*AS Constructed*  
~~HIGHWAY CONSTRUCTION BID PLANS OF PROPOSED~~  
FEDERAL AID PROJECT NO. NH 2852-014  
U.S. HIGHWAY 285  
CHAFFEE COUNTY  
CONSTRUCTION PROJECT CODE NO. 13998

AS CONSTRUCTED INFORMATION  
CONTRACTOR D.G. HUSKINS  
Project ENGINEER LARRY CISNEROS  
(Project or Resident)  
PROJECT STARTED April 21, 2003  
PROJECT COMPLETED July 17, 2003  
AS CONSTRUCTED PLANS  
APPROVED Billy Beal  
FINAL ENGINEER 9/3/03  
TITLE DATE  
J.J.S./REGION 5

Computer File Information				Sheet Revisions				As Constructed				Title Sheet				Project No./Code	
Creation Date:	16 OCT 02	Initials:	KEM	(R-1)	2/18/03	Revised Sheets 1,2,5,6,36	KEM	No Revisions:								NH 2852-014	13998
Last Modification Date:	18 FEB 03	Initials:	KEM	(R-1)	2/18/03	Deleted Sheet 30	KEM	Revised:	July 17, 2003	Designer:	WILCOXON	Structure Numbers					
Full Path:	C:\13998\			(R-X)				Void:		Detailer:	MAGOWAN	Sheet Subset:		Subset Sheets:		Sheet Number	1
Drawing File Name:	title sheet.DWG			(R-X)													
Acad Ver.	R2002	Scale:	AS SHOWN	Units:	FEET	(R-X)

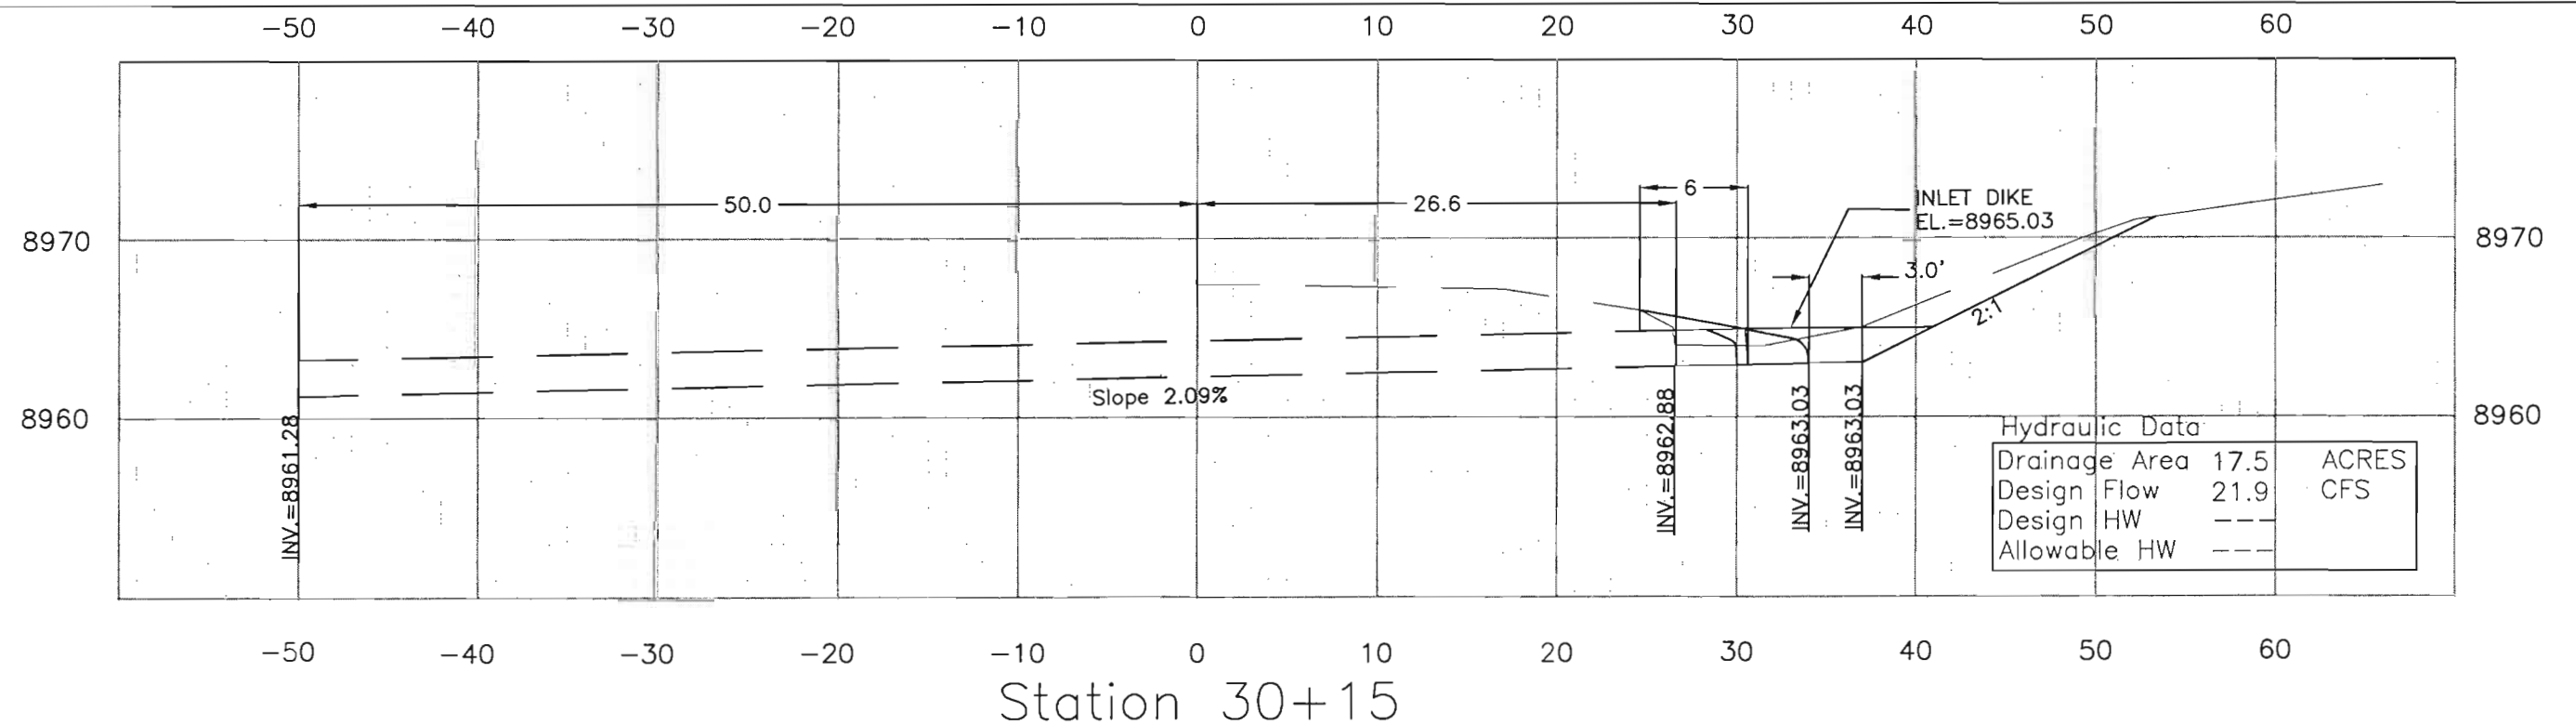
Sta. 30+15 24" 76.5' CMP  
~~Req'd~~ Remove 2' CMP Rt.  
~~Req'd~~ Removed End Section Rt.  
~~Req'd~~ Extend 6' Rt.  
~~Req'd~~ Steel End Section Rt.  
~~Req'd~~ Dike Rt.  
~~Req'd~~ Inlet Grading Rt.

Station 46+78

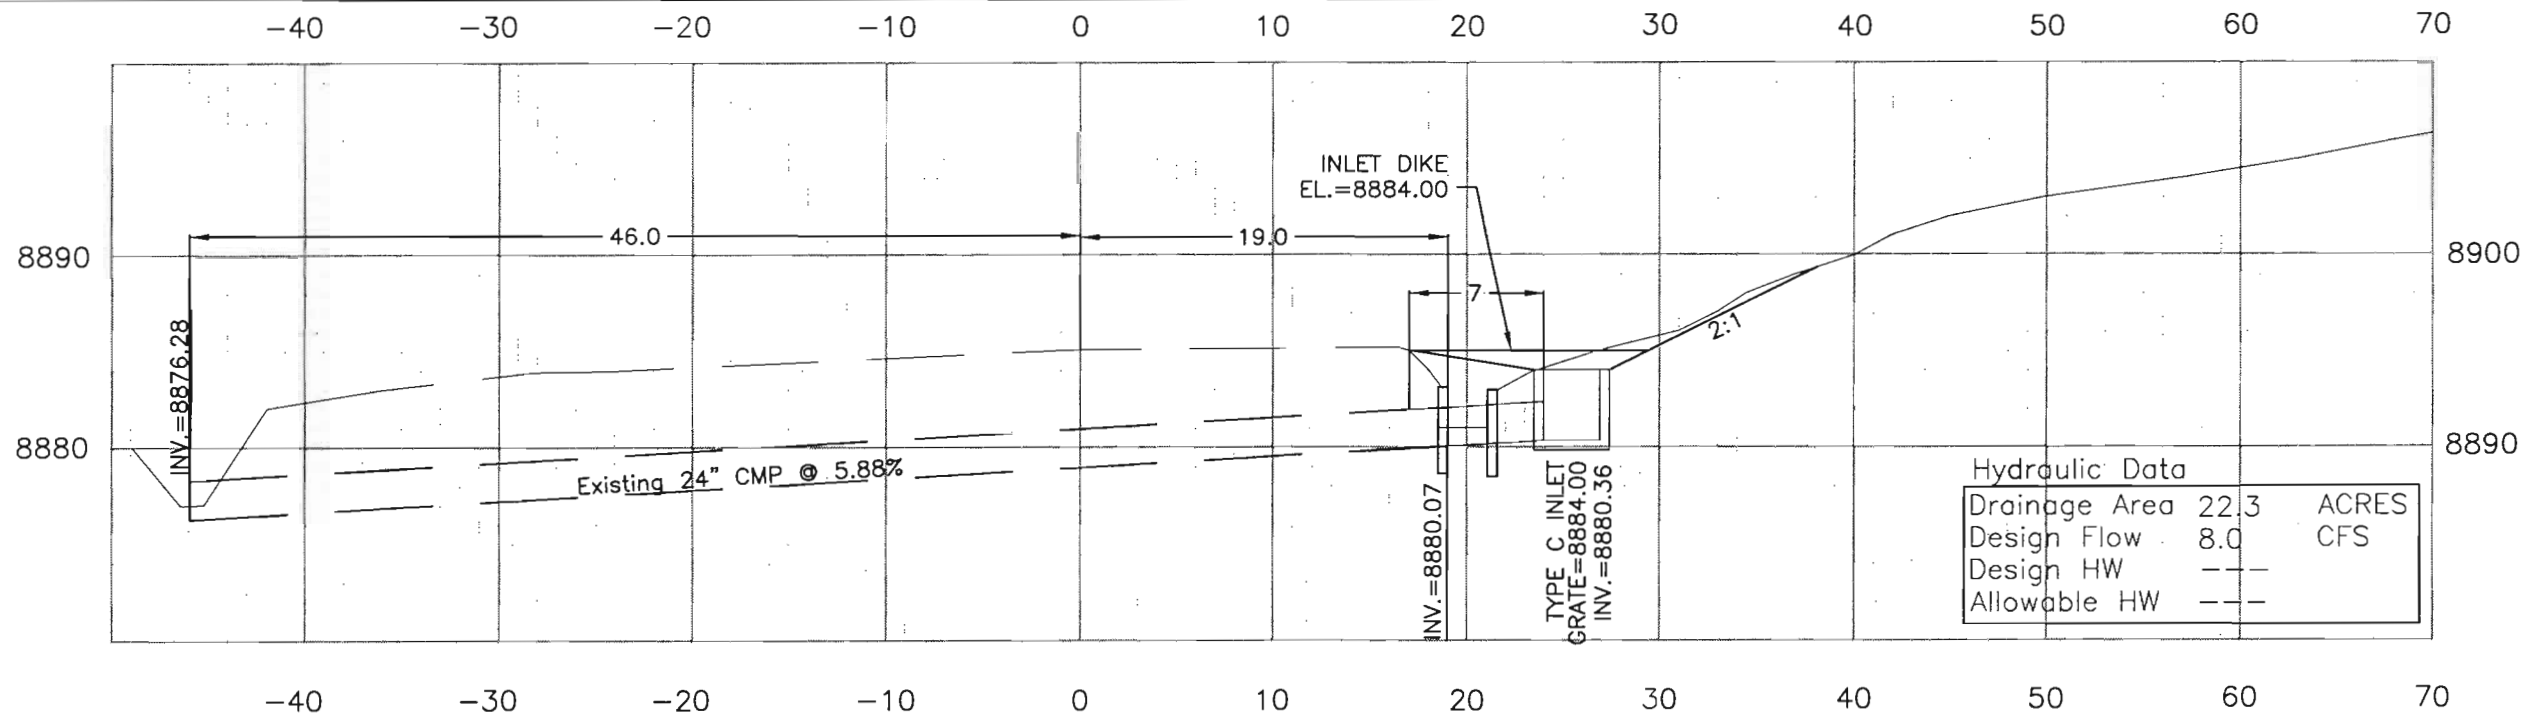
*Cleaned*  
 Sta. 46+78 24"x65' CMP  
 Req'd Removed Inlet Rt.  
 Req'd Removed 2' CMP Rt.  
 Req'd Extended 27' Rt.  
 Req'd Inlet Type C (3.5ft.) Rt.  
 Req'd Inlet Dike Rt.  
 Req'd 12" Riprap Rundown Rt.  
 See Detail or as directed by the Engineer  
 Req'd Geotextile Separator Class A Rt.  
 Req'd Inlet Grading Rt.

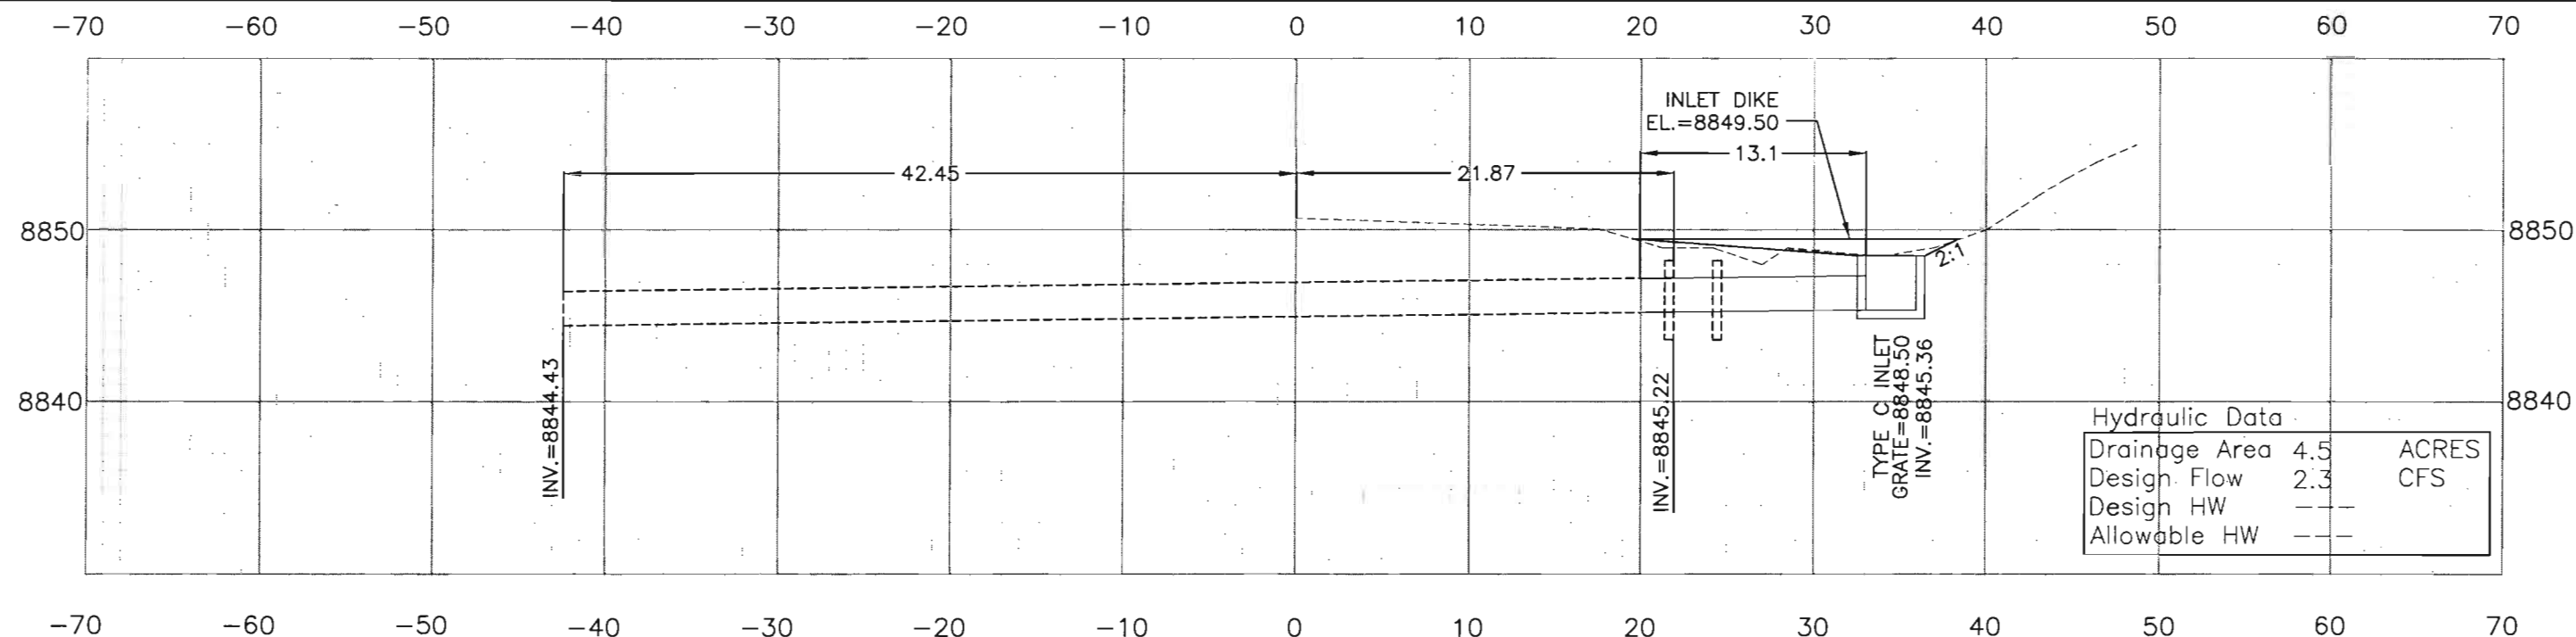
Sta. 55+02 24'X64.3' CMP  
~~Req'd Remove Inlet Rt.~~  
~~Req'd Remove 2' CMP Rt.~~  
~~Req'd Extend 13.1' Rt. 13.0'~~  
 Placed ~~Req'd Inlet Type C (3ft) Rt.~~  
 Placed ~~Req'd Inlet Dike Rt.~~  
~~Req'd Inlet Grading Rt.~~

Station 61+40

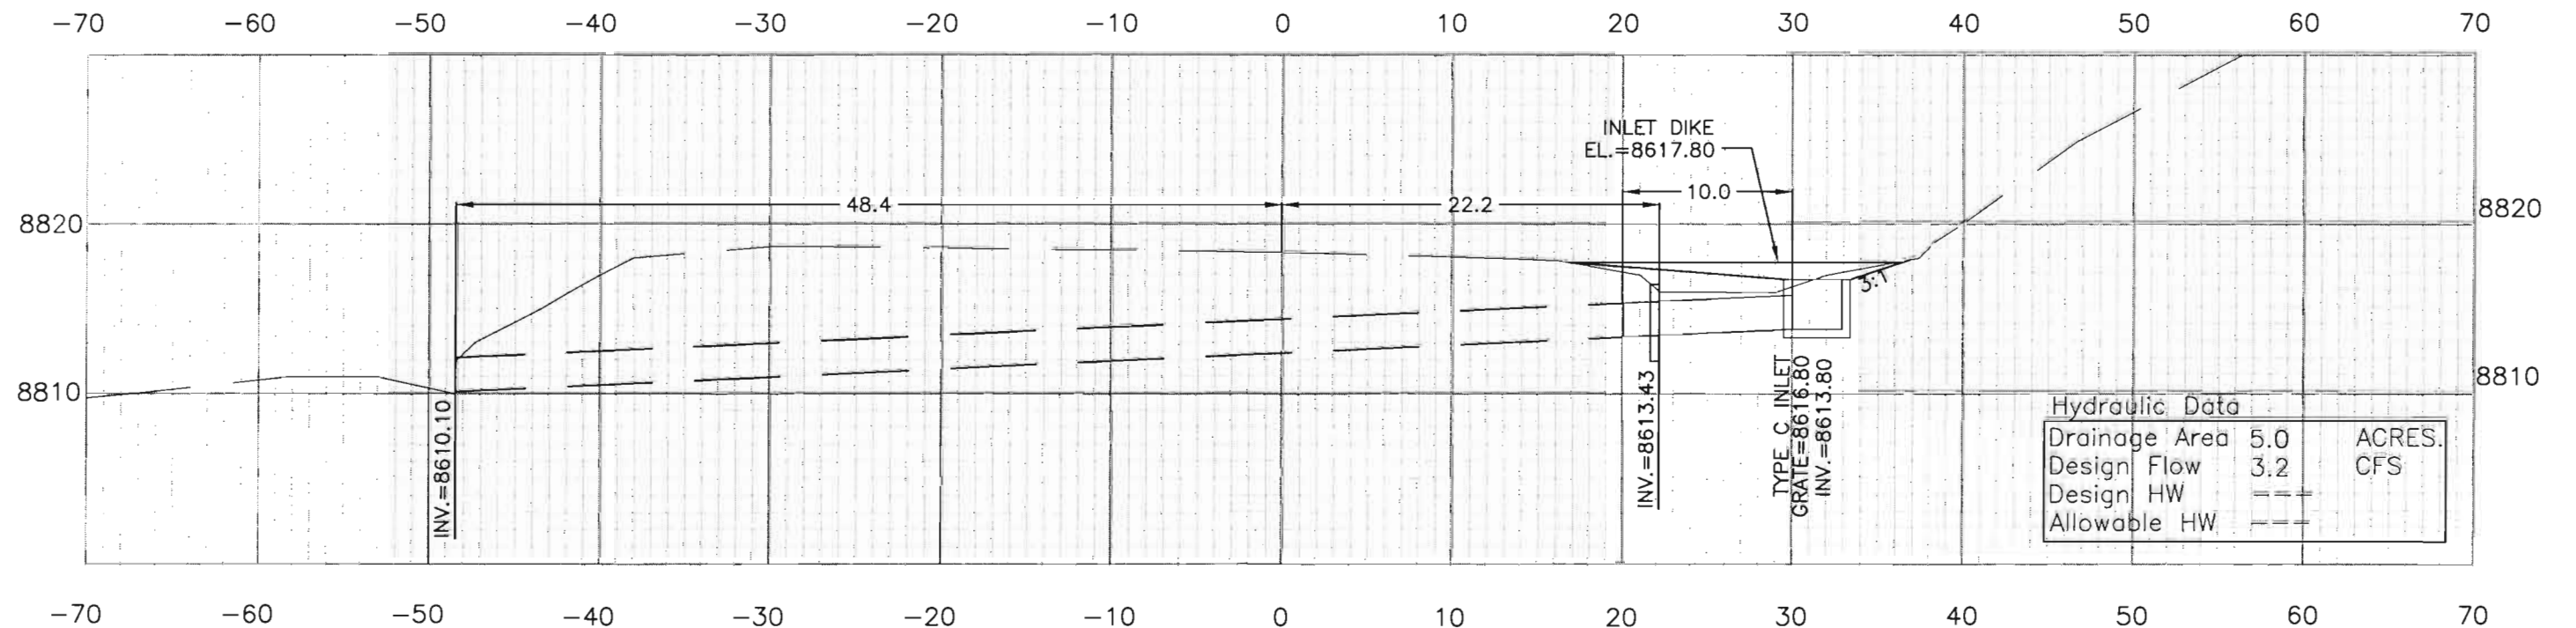
Sta. 61+40 24"X70.6' CMP  
 Req'd Remove 2' CMP  
 Req'd Remove Headwall Rt.  
 Req'd Clear Culvert  
 Req'd Extend 40' Rt.  
 Req'd Inlet Type C (3ft) Rt.  
 Req'd Inlet Dike Rt.  
 Req'd Inlet Grading Rt.

Station 65+71

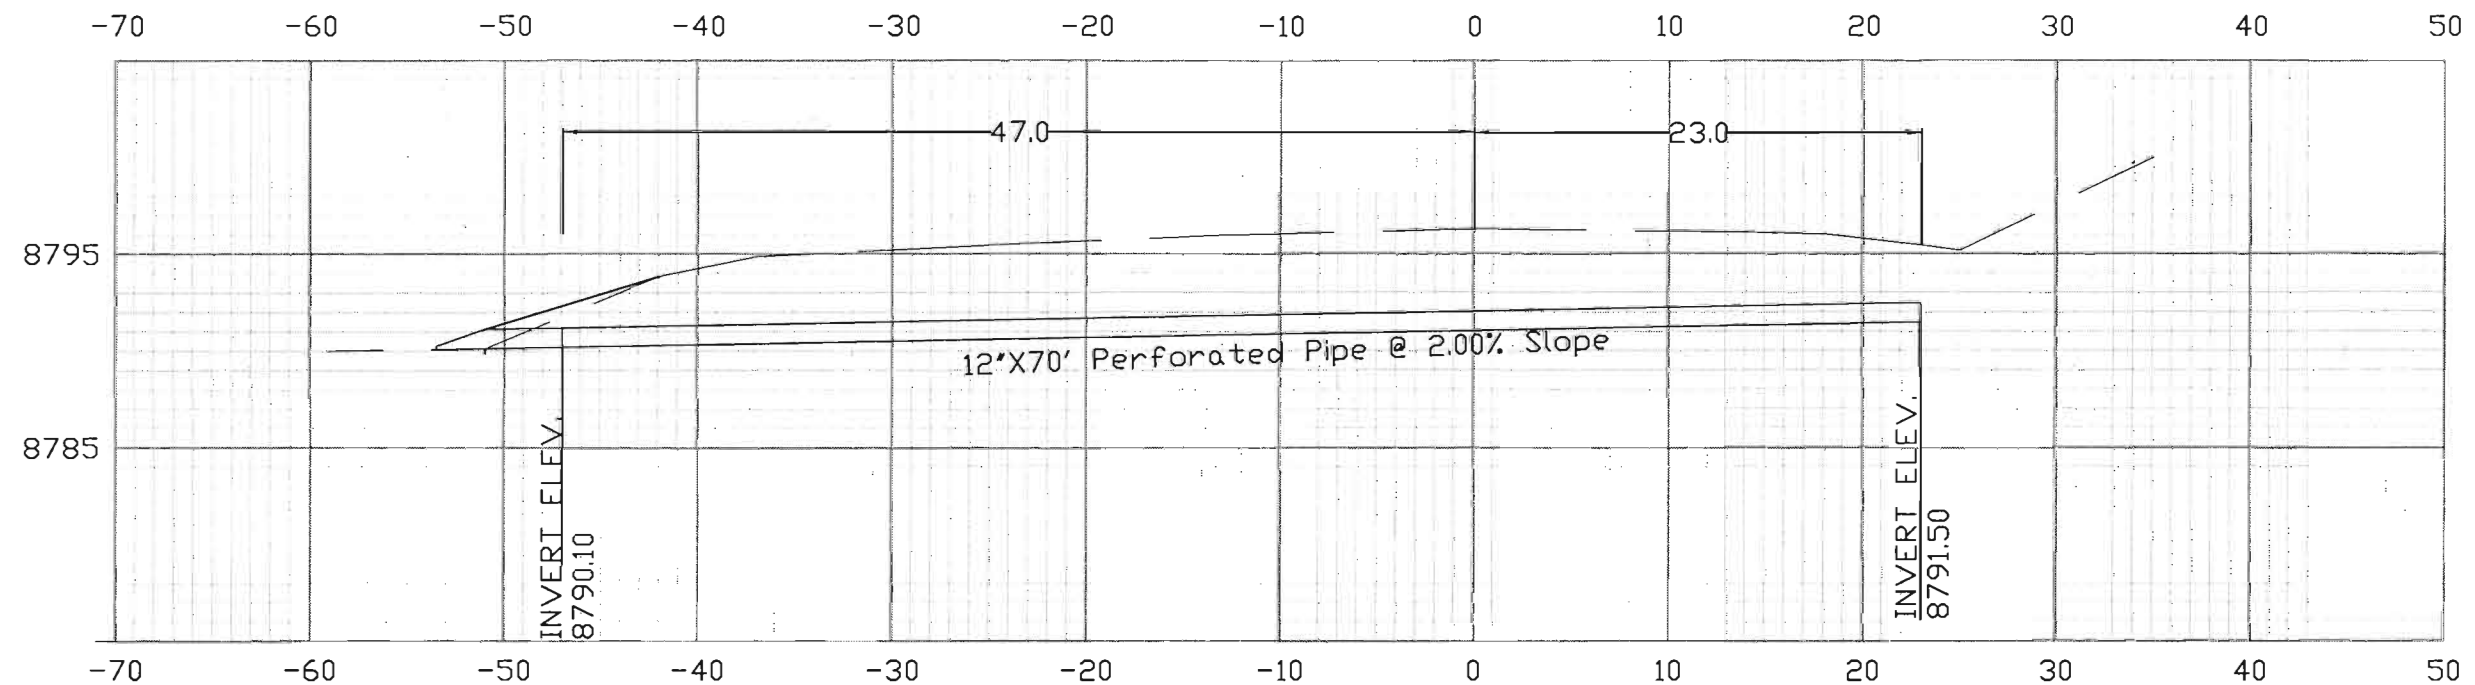
Sta. 65+71  
 Placed Req'd 12' X 70' Perforated Pipe, Skew 81° Rt.  
 Placed Req'd 1/2" X 1/2" Galvanized Hardwire Cloth Lt.  
 Placed Req'd 12' Concrete End Section Lt.  
 Placed Req'd 99° Elbow Connection Rt.  
 See Underdrain Detail  
 Placed Backfill (Flow Fill) 13.8 C.Y.

Station 69+35

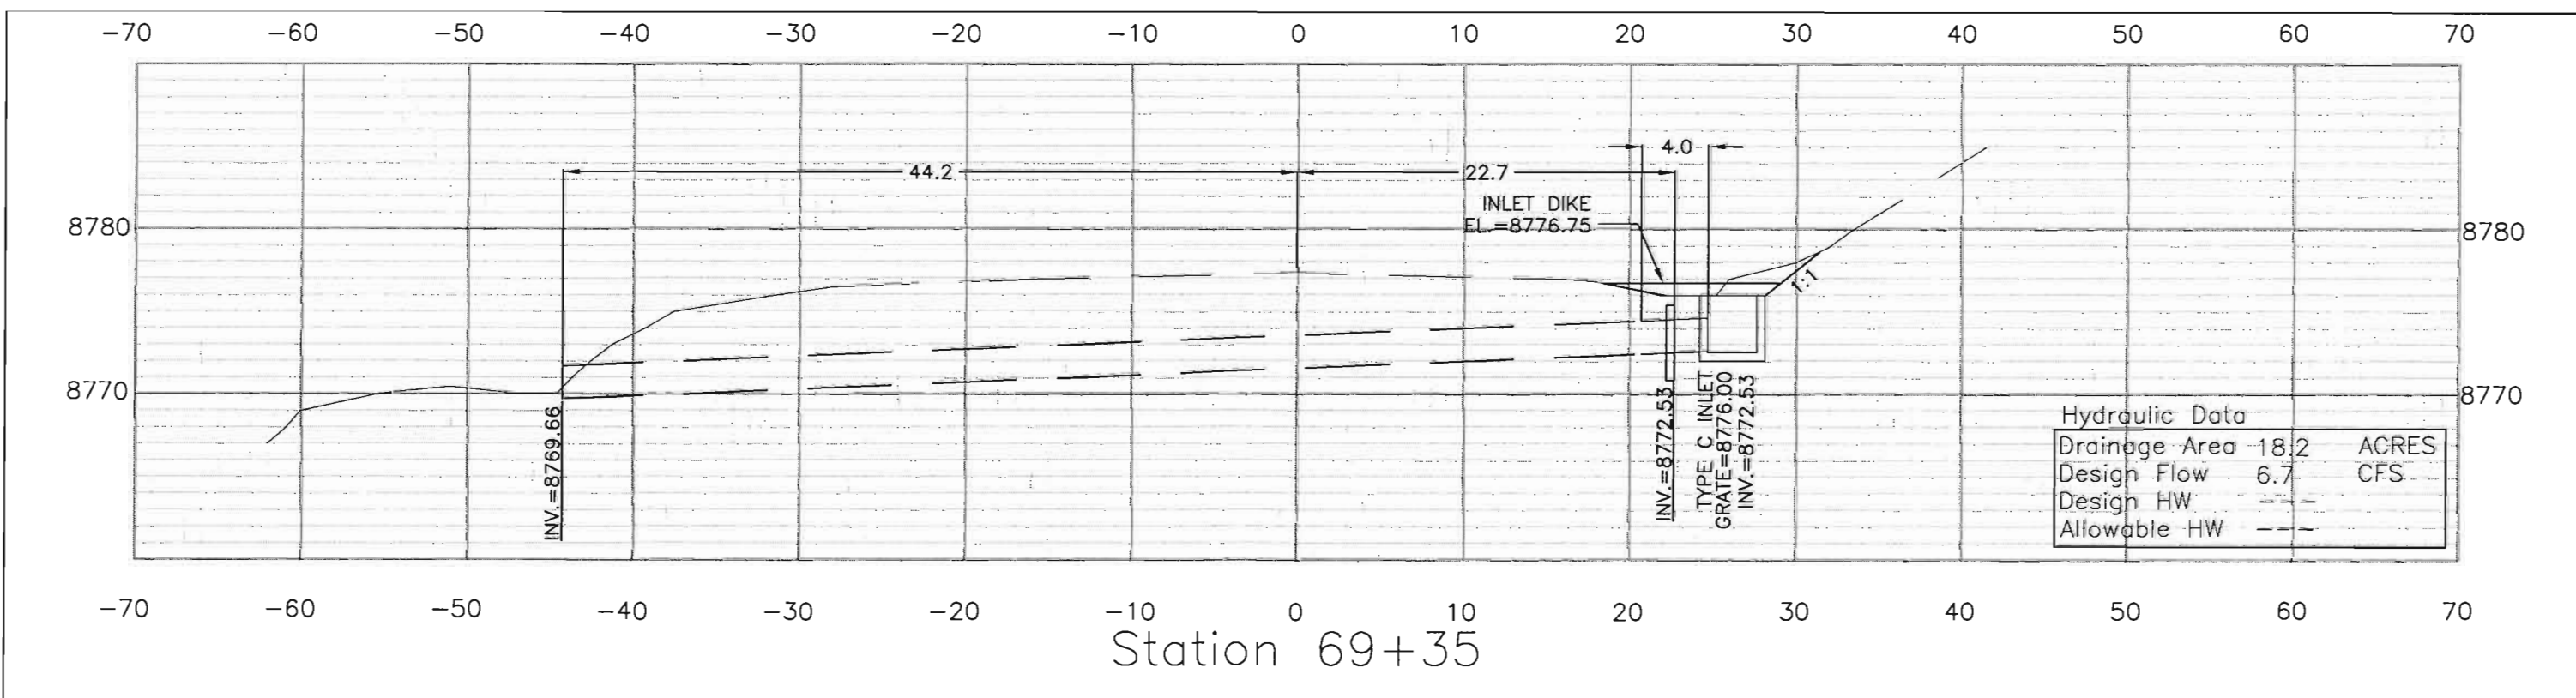
Sta. 69+35 24"X67' CMP  
 Req'd Remove Headwall Rt. Inlet  
 Req'd Remove 2' CMP Rt.  
 Req'd Extend 4' Rt. 3'  
 Placed Req'd Inlet Type C (3.5ft) Rt.  
 Placed Req'd Inlet Dike Rt.  
 Completed Req'd Inlet Grading Rt.  
 Cleaned Culvert
